HYDROLOGY K17/D39 1 PLAN

RE: REVISED CERTIFICATION FOR RETAIL SPACE
HEIGHTS RESERVOIR ADDITION W 1/2 OF TRACT 30
ENGINEER'S STATEMENT DATED JANUARY 31, 1986 (K-17/D39)

REF: DRAINAGE PLAN FOR RETAIL SPACE (K17-D39) ON WEST ½ TRACT 30 OF HEIGHTS RESERVOIR ADDITION, FOR BUILDING PERMIT, ENGINEERING DRAWINGS STAMPED AND DATED 10/7/85, RECEIVED 10/8/85

RE: DRAINAGE PLAN FOR RETAIL SPACE (K17-D39) ON WEST ½ TRACT 30 OF HEIGHTS RESERVOIR ADDITION, ENGINEERING DRAWINGS STAMPED AND DATED 8/2/85, REVISED 8/12/85

E-114

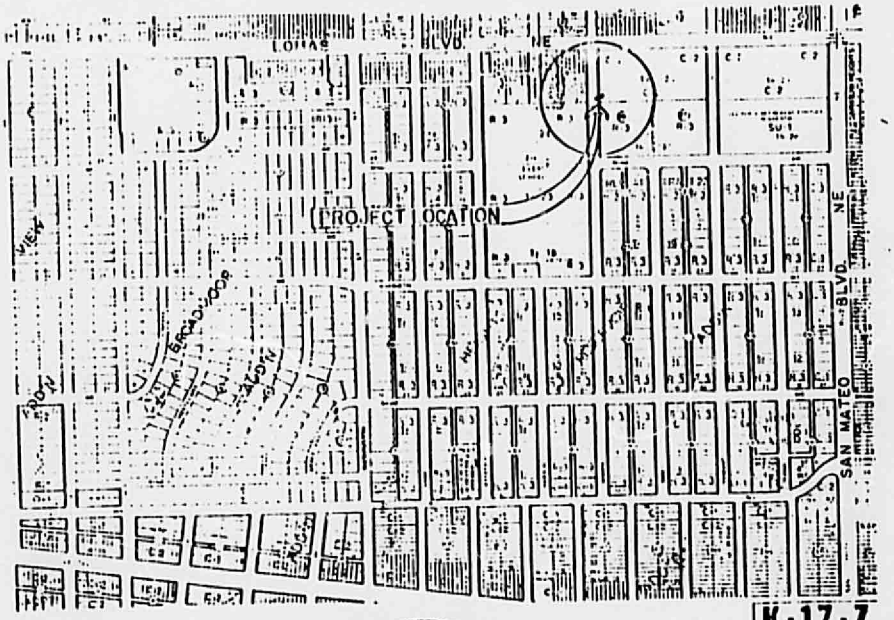
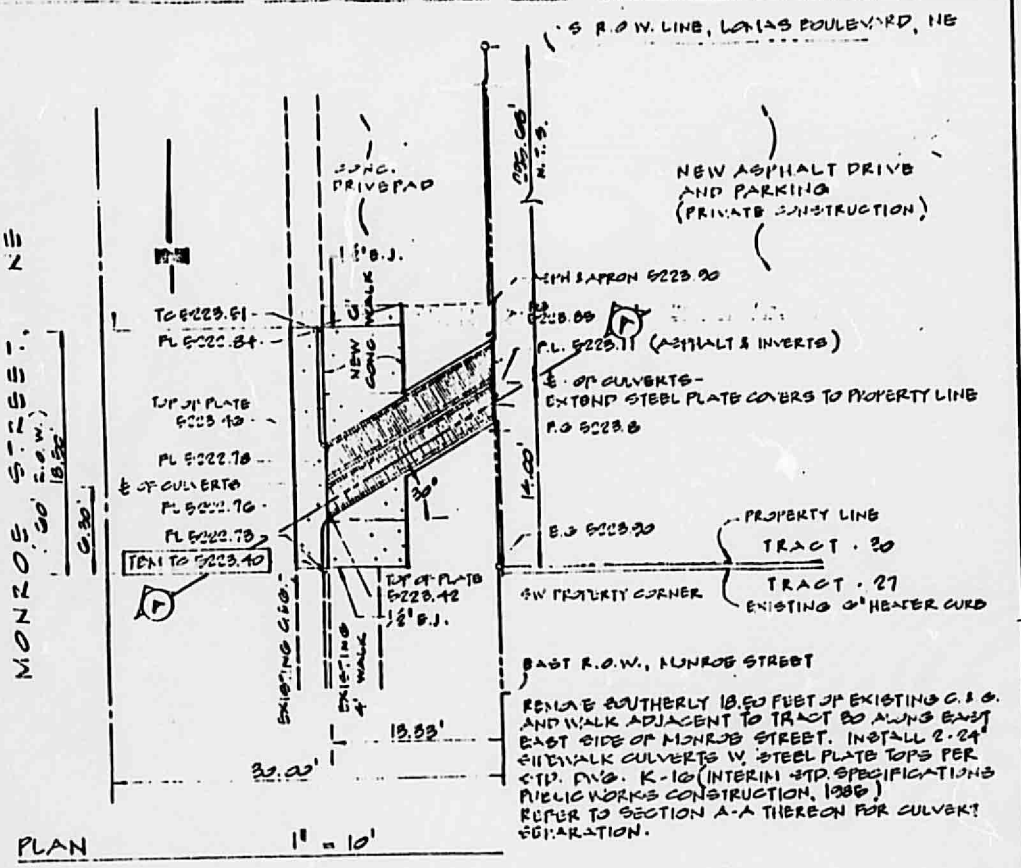
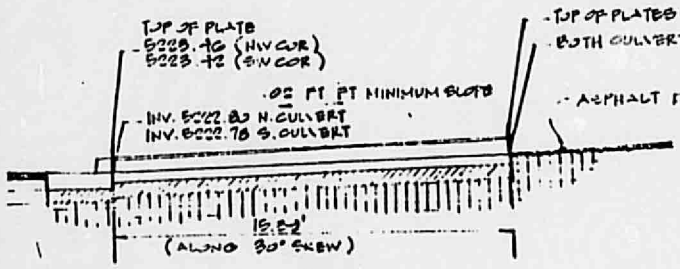
4. I have been unable to obtain copies of the Special Order 19 for this project (Dwg. E-114) which indicate that the facility has been inspected or approved. It is in place as designed, however. I have included copies of the design as approved by Sergio Miranda and readable copies of the same from our files.

REMOVE SOUTHERLY 18.50 FEET OF EXISTING C.&G. AND WALK ADJACENT TO TRACT 30 ALONG EAST EAST SIDE OF MONROE STREET. INSTALL 2-24" SIDEWALK CULVERTS W. STEEL PLATE TOPS PER STD. DWG. K-10 (INTERIM STD. SPECIFICATIONS PUBLIC WORKS CONSTRUCTION, 1986) REFER TO SECTION A-A THEREON FOR CULVERT SEPARATION.

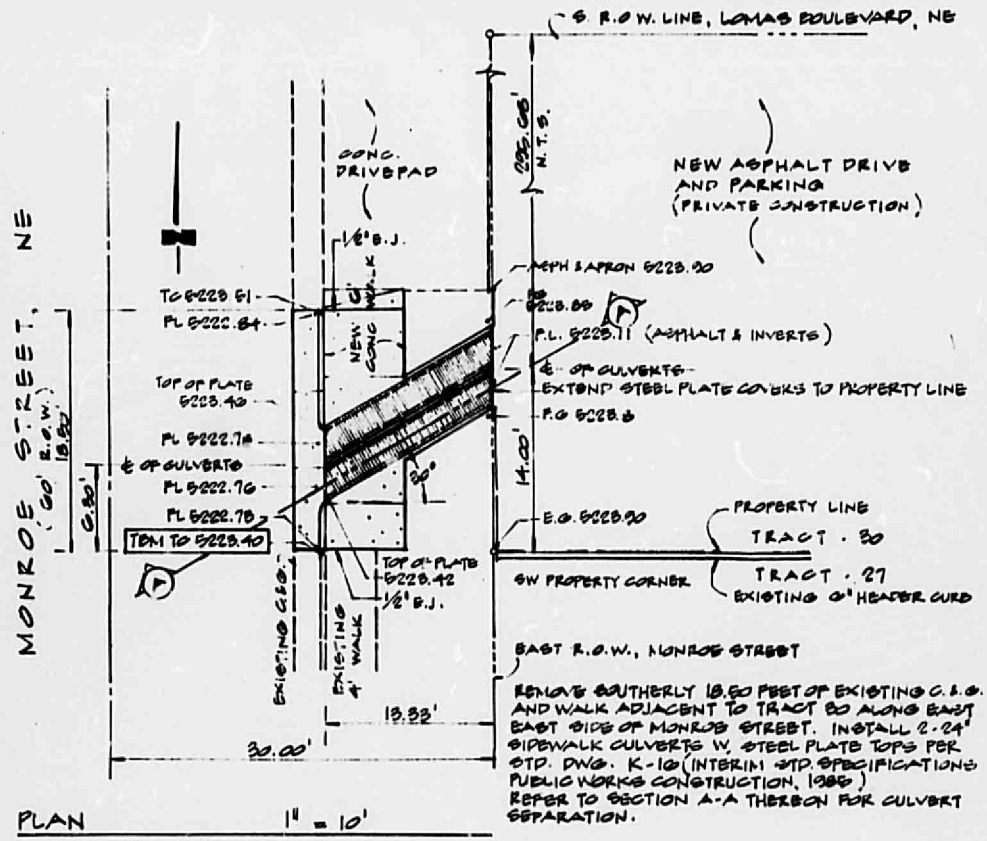
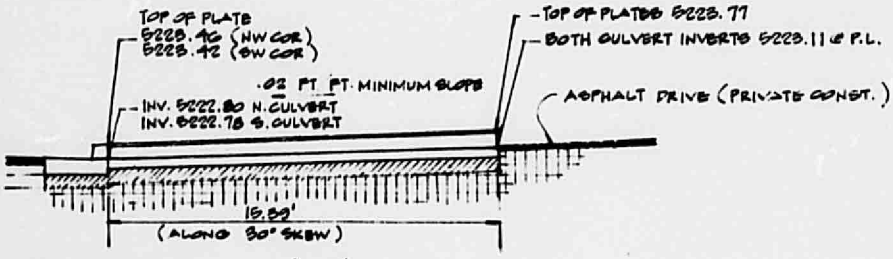
7. Two 24" sidewalk culverts are to be constructed at the discharge point to Monroe. A simple flow analysis for these appears at the lower left of sheet. The location of an existing exit drain to Monroe, which appears to be little more than two broken out curb stones, is to be the location of a new 24' drive pad. I've included a copy of the tentative Special Order 19 design.

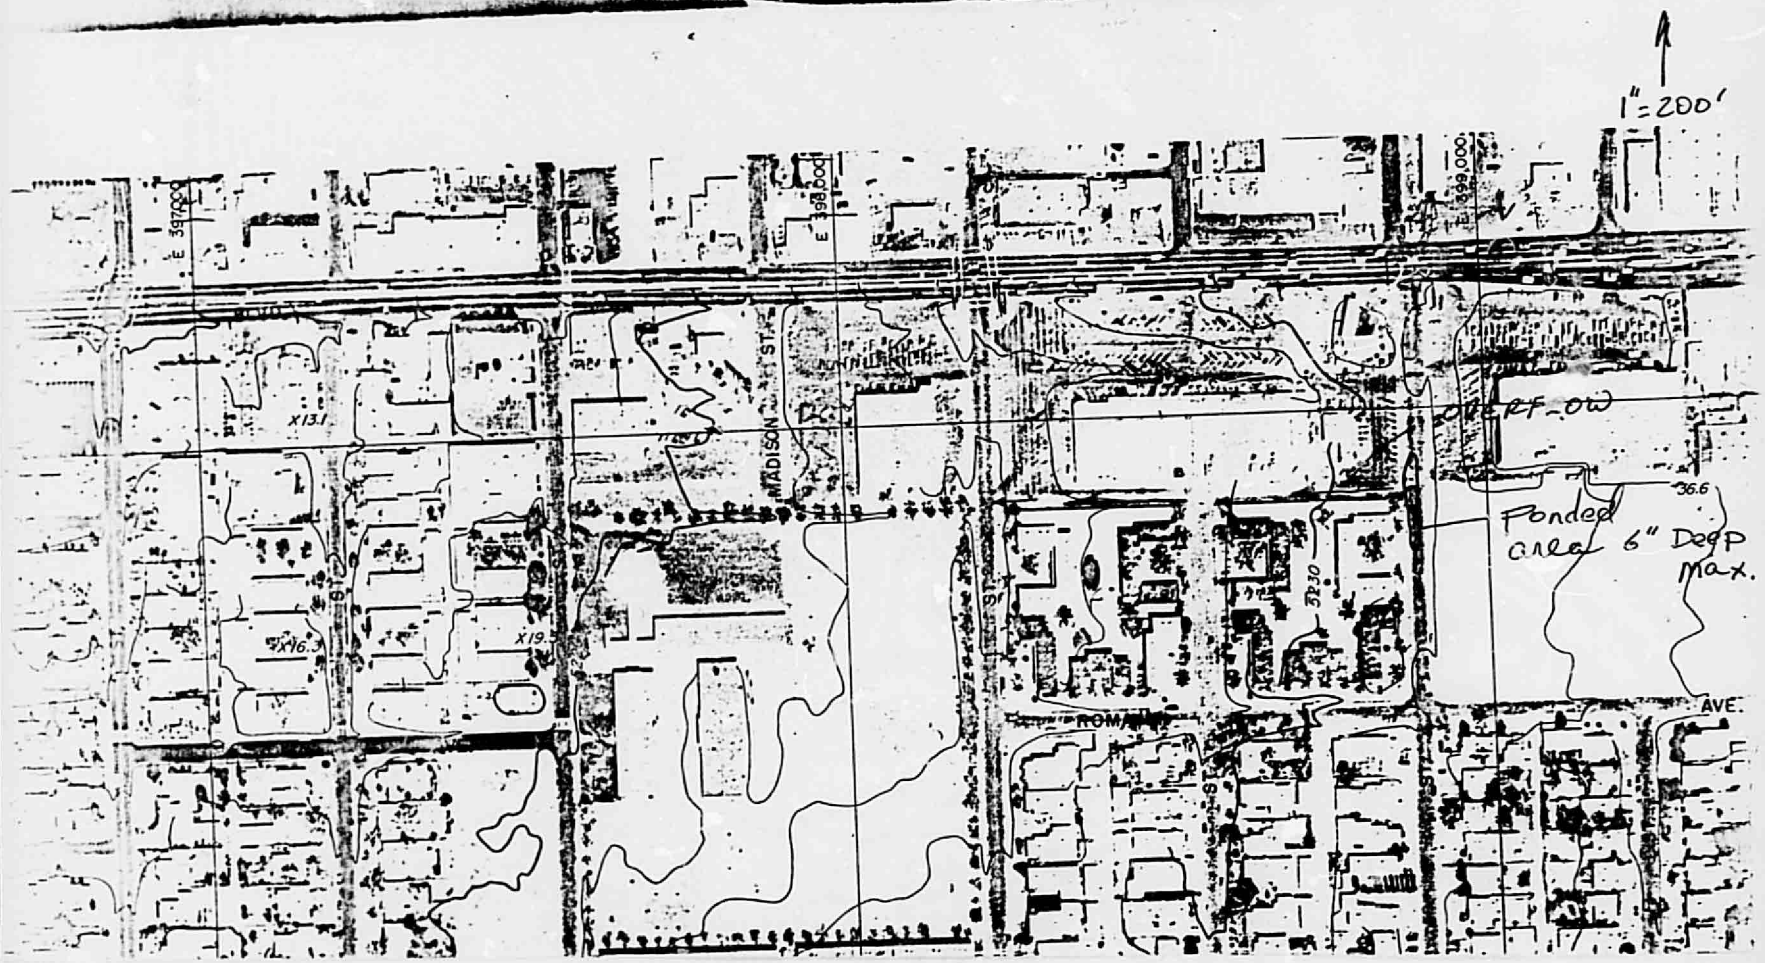
3. Any details that are not applicable will need to be removed from the as-built plan, and any additional details will need to be included (Z - 24" x 8" drains cast in place).

Swale between Building has changed to a concrete channel due to Disposal problem.

drainageway now appears on the plan together with capacity and flow depth computations. (Due to the layout of the original drawing, this detail appears near the upper right-hand portion of the sheet.) The previous flowline across the parking lot and the proposed location of the new flowline have both been identified.

3. I have included a view of drain between the buildings as it was constructed. Our field measurements indicate that the slope through this drain still complies with our design. Originally, the area through which the drain runs was supposed to serve also as an access to a refuse compactor on the west side of John Brooks' Food Town. With the repositioning of the compactor, this was no longer necessary, thus the drain was amended. Flow capacity calculations appear on the sheet below the as-built drain detail.
